ADA ACCESSIBILITY REPORT

The Fauquier County Board of Supervisors

Fauquier County, Virginia

SAMAHA ASSOCIATES, P.C.

FIRST FLOOR

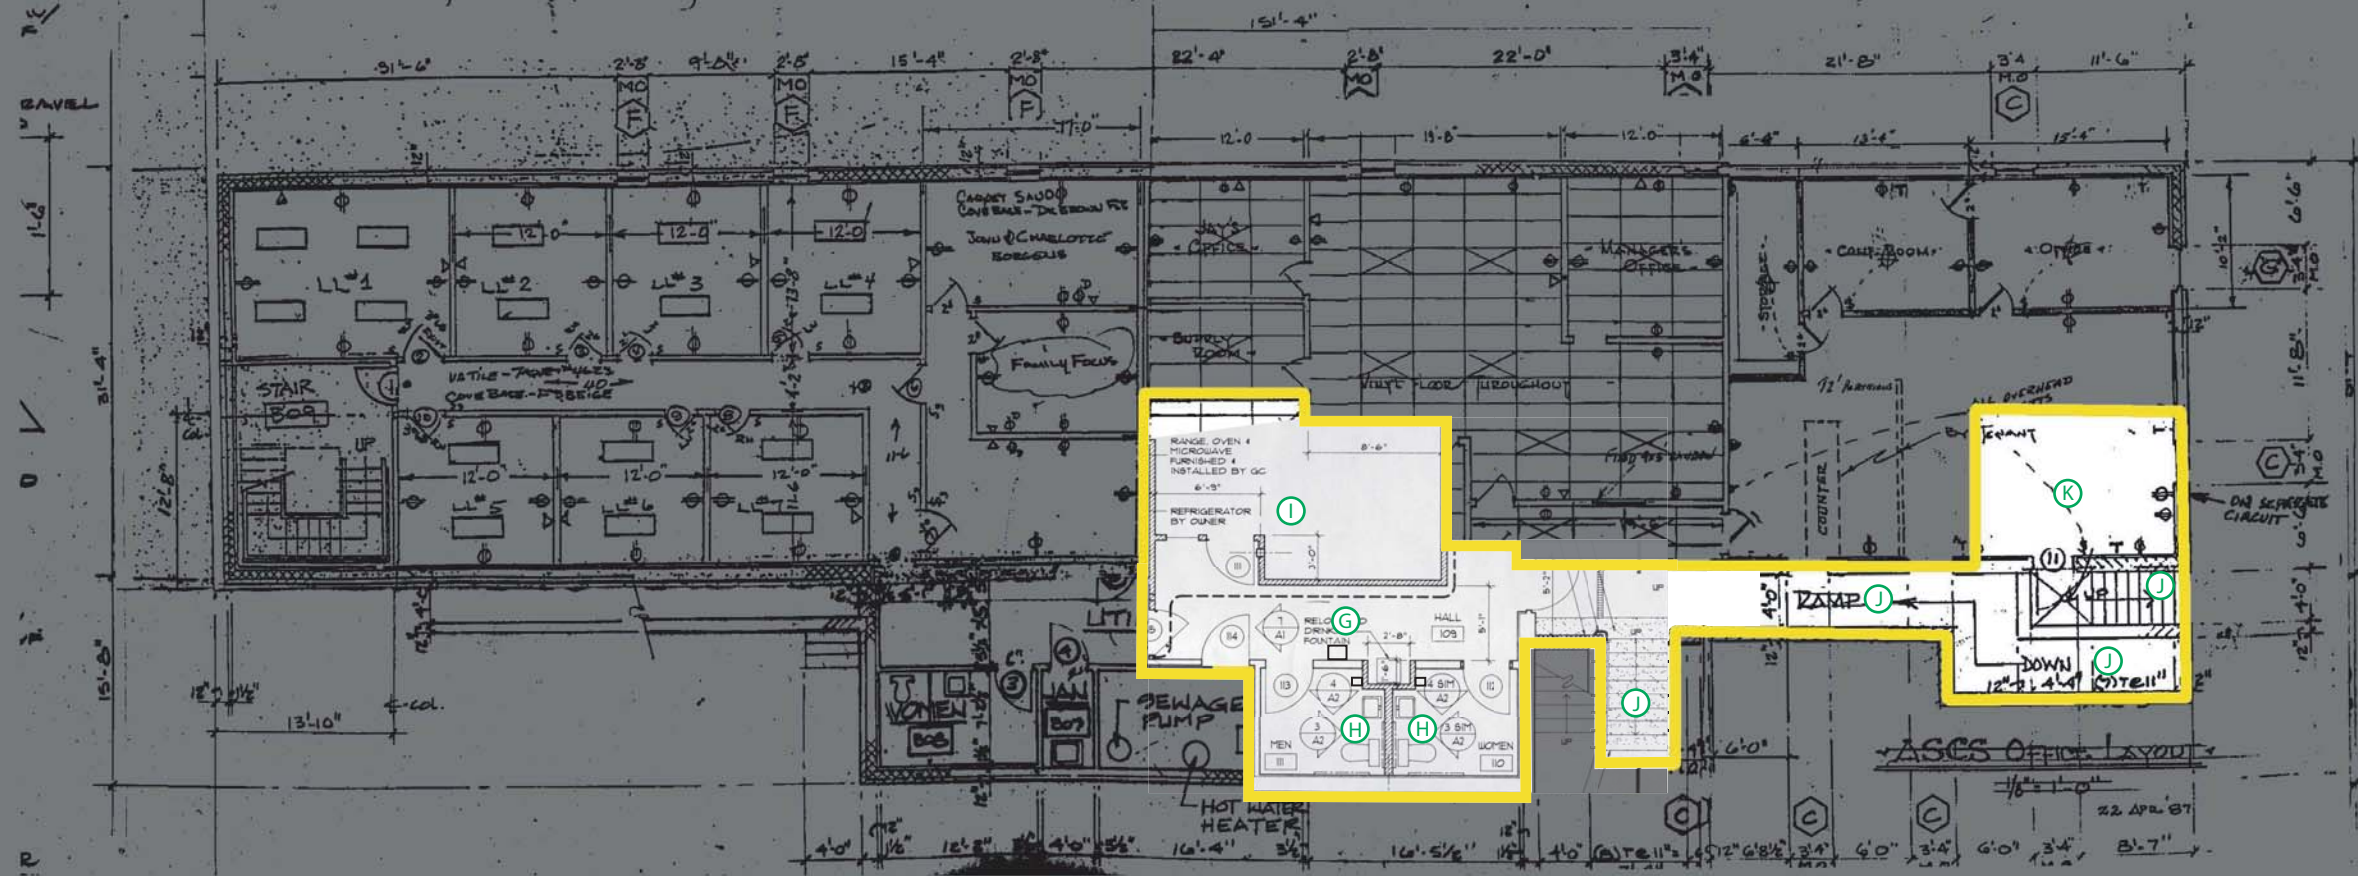
| <u>Plan Symbol</u> | <u>Item</u> | <u>ADAAG Reference</u> | <u>ANSI- A117.1- 2003 Reference</u> | <u>Requirement</u> | <u>Required Effort to Comply with the ADA</u> | <u>Budget Estimate</u> |
|------------------------|--|----------------------------|---|--|---|------------------------|
| A | Omitted Handrail | 4.9.4 | 505.2 | Required at both sides of all stairs. Location: Handrails shall be provided on both sides of stairs and ramps. | Provide new required handrails | \$ 5,000.00 |
| B | Reduced Clear Height under Stair | 4.4.2 | 307.4 | If vertical clearance of an area adjoining an accessible route is reduced to less than 80", a barrier shall be provided. Reduced Vertical Clearance: Guardrails or other barriers shall be provided where object protrusion is beyond the limits allowed by Sections 307.2 and 307.3 and where the vertical clearance is less than 80" above the floor. The leading edge of such guardrail or barrier shall be 27" max. above the floor. | Add railing or fixed furniture below the area of low clearance. | \$ 1,000.00 |
| C | Open Risers | 4.9.2 | 504.3 | Open Risers are not permitted. Open Risers: Open risers shall not be permitted. | Replace treads with closed risers | \$ 7,500.00 |
| D | Electric Water Cooler Obstruction | 4.4.1 | 307.2 | Protruding Objects. Objects projecting from walls with their leading edges between 27" & 80" above the finished floor shall protrude no more than 4" into walks, halls, corridors passageways or aisles. Protusion Limits: Objects with leading edges more than 27" and not more than 80" above the floor shall protrude 4" max. horizontally into the circulation path. | Provide model with compliant extension to below 27" or relocate electric water cooler. | \$ 7,500.00 |
| E | 9" Protruding Depth at Paper Towel Dispenser | 4.4.1 | 307.2 | Protruding Objects. Objects projecting from walls with their leading edges between 27" & 80" above the finished floor shall protrude no more than 4" into walks, halls, corridors passageways or aisles. Protusion Limits: Objects with leading edges more than 27" and not more than 80" above the floor shall protrude 4" max. horizontally into the circulation path. | Replace Paper Towel Dispenser with ADA accessible model surface mounted or recessed model. (4) | \$ 4,000.00 |
| F | 36" Perpendicular Depth Clearance at Doorway | 4.13.6 | Table 404.2.3.1 | Latch side approach to push side, without closer: 24" beyond latch side of door, 42" perpendicular to doorway. Maneuving Clearances at Manual Swing Doors: For latch side approach from push side, 24" parallel to doorway beyond latch side of door, 42" perpendicular to doorway. | Relocate interior partitions and replace door and frame to accommodate required clearances. (3) | \$ 12,000.00 |
| G | Pay Phone Protruding into Accessible Route | 4.4.1 | 307.2 | Protruding Objects. Objects projecting from walls with their leading edges between 27" & 80" above the finished floor shall protrude no more than 4" into walks, halls, corridors passageways or aisles. Protusion Limits: Objects with leading edges more than 27" and not more than 80" above the floor shall protrude 4" max. horizontally into the circulation path. | Replace with accessible pay phone. | \$ 1,500.00 |

SECOND FLOOR

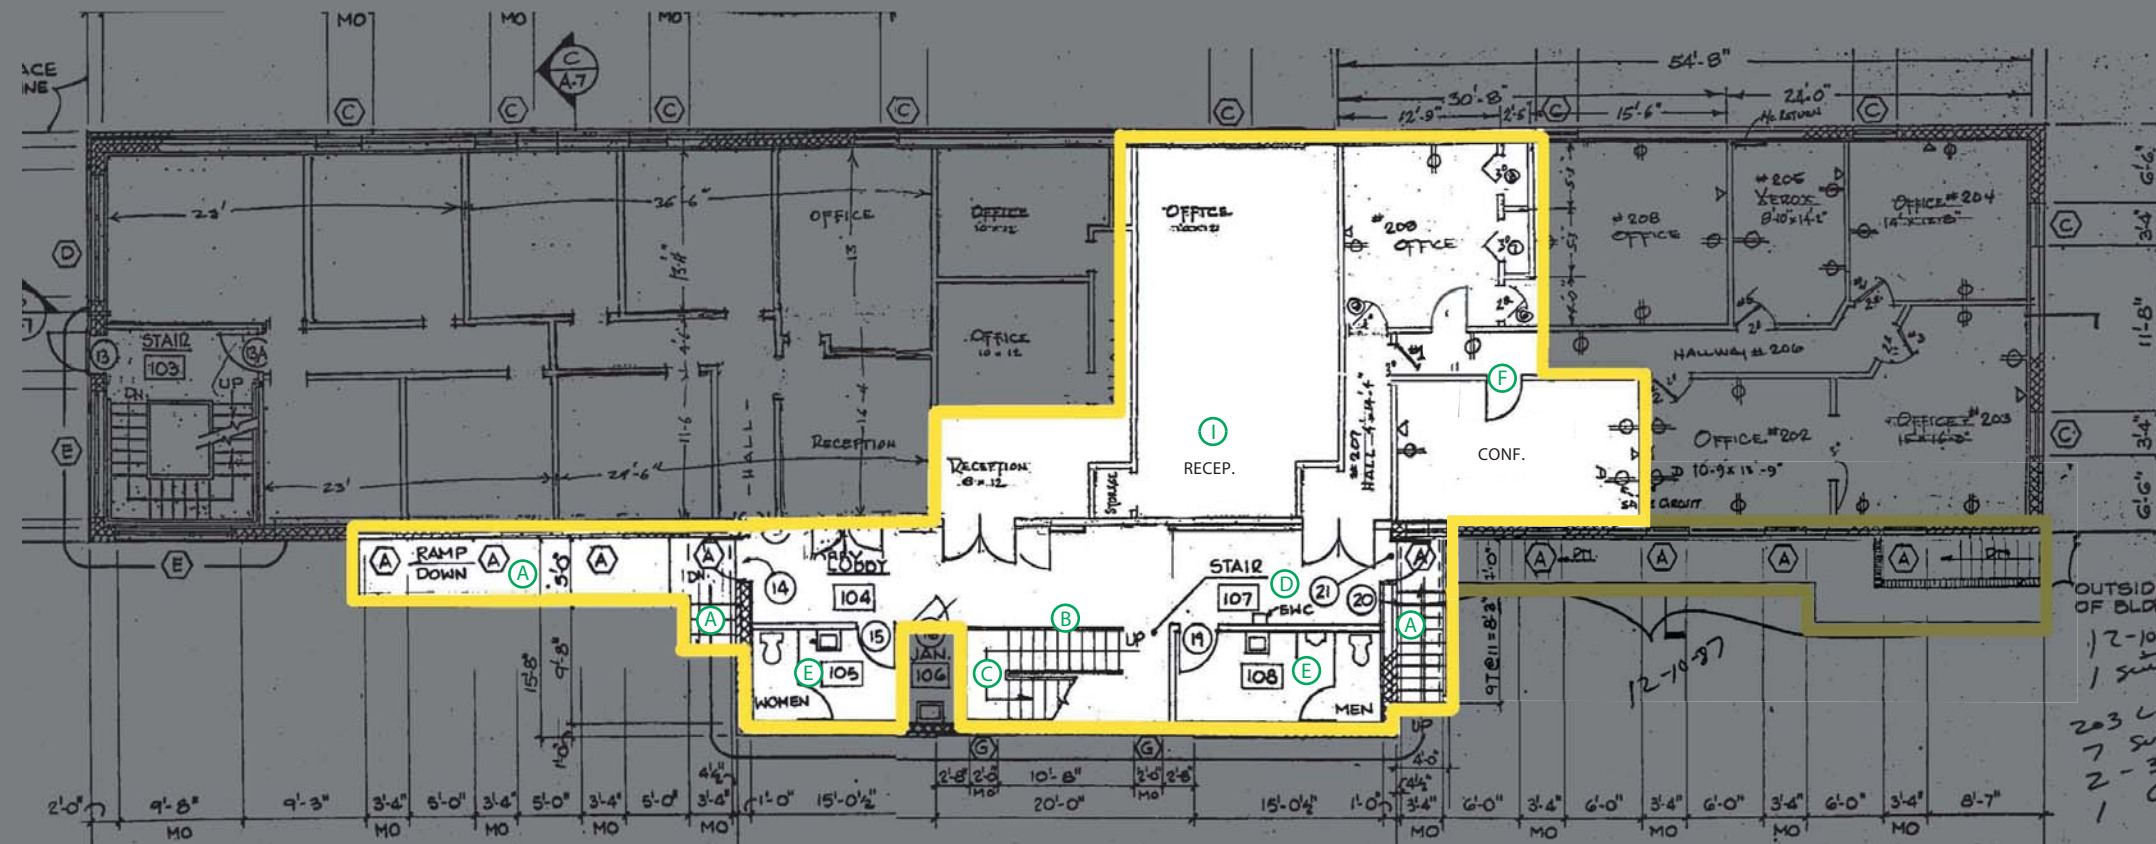
| I | No Accessible Portion of Counter | 7.2 | 904.3.2 | A portion of the main counter, minimum 36" in length, maximum of 36" above the floor, shall be provided. Forward Approach: A portion of the counter surface 30" min. in length and 36" max. in height above the floor shall be provided. A clear space complying with section 305, positioned for a forward approach to the accessible counter shall be provided. Knee and toe clearance complying with Section 306 shall be provided under the accessible counter. | Provide compliant height service counter (2) | \$ 1,000.00 |
| J | Omitted Handrail | 4.9.4 | 505.2 | Required at both sides of all stairs. Location: Handrails shall be provided on both sides of stairs and ramps. | Provide new required handrails | \$ 2,500.00 |
